October 3, 1984

HOPE CREEK GENERATING STATION  
DOCKET NO. 50-354  
DRAFT SAFETY EVALUATION REPORT  
OPEN ITEM STATUS

Attachment 1 is a current list which provides a status of the open items identified in Section 1.7 of the Draft Safety Evaluation Report (SER). Items identified as "complete" are those for which PSE&G has provided responses and no confirmation of status has been received from the staff. We will consider these items closed unless notified otherwise. In order to permit timely resolution of items identified as "complete" which may not be resolved to the staff's satisfaction, please provide a specific description of the issue which remains to be resolved.

HOPE CREEK GENERATING STATION FINAL SAFETY ANALYSIS REPORT	
ISOLATION BETWEEN CLASS-IE POWER SUPPLIES AND NON CLASS-IE LOADS- TRIPPING CIRCUIT BREAKER	
FIGURE 430.33-1	AMENDMENT 4, 1/84

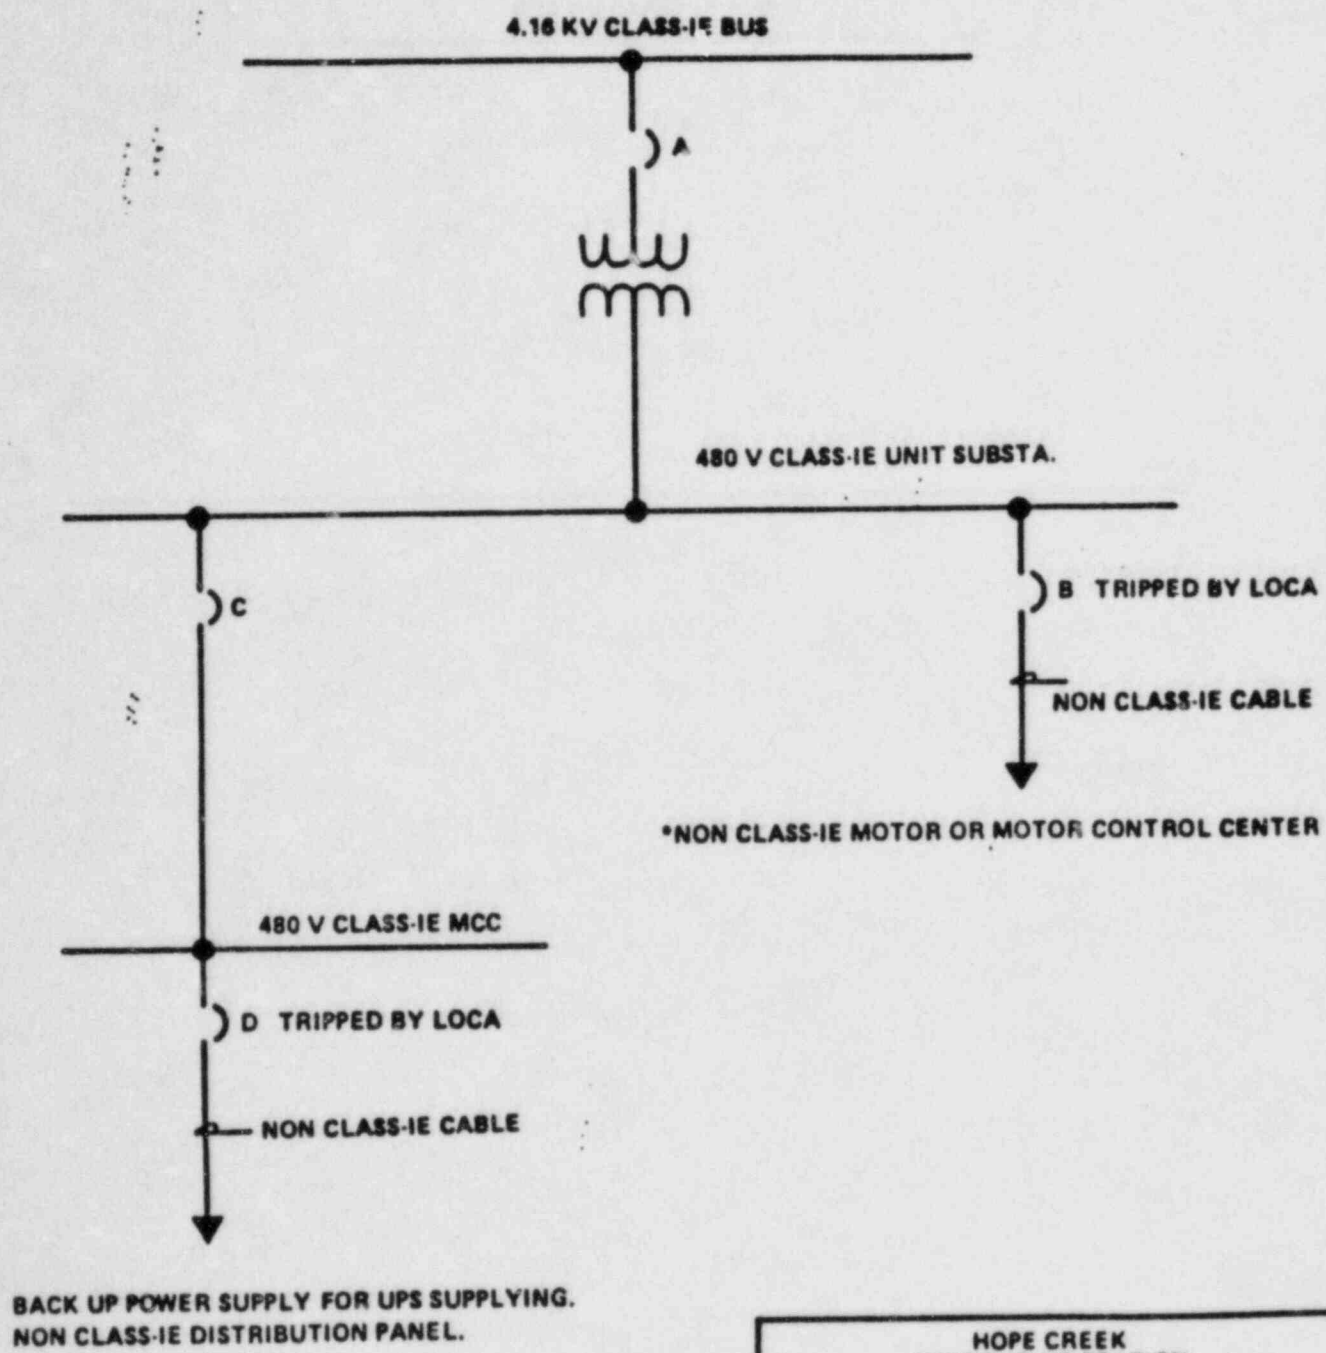
By Amendment 4 to the PSAR, the applicant indicated that protective device coordination studies show that the single breaker time overcurrent trip characteristics will trip to clear a fault prior to initiation of a trip of a upstream breaker. Identification of all non-Class 1E circuits being isolated using a single breaker trip by LOCA signal, periodic testing of breaker coordination, and capability of breaker to trip prior to any versus only upstream breaker and for all versus only circuit faults, will be pursued with the applicant.

QUESTION 430.33 (SECTION 8.3.1 and 8.3.2)

Protective device coordination studies for devices shown in Figure 430.33-1 have shown that the time-overcurrent trip characteristics of circuit breakers A, B, C, and D are such that:

Response to Question 430.33 has been revised to provide the requested information.

Periodic testing of the breaker time-overcurrent trip characteristics will be performed to demonstrate that the circuit breaker trip function remains within required limits. Table 430.33-1 identifies the non-Class 1E loads that are supplied through circuit breakers B and D of Figure 430.33-1.
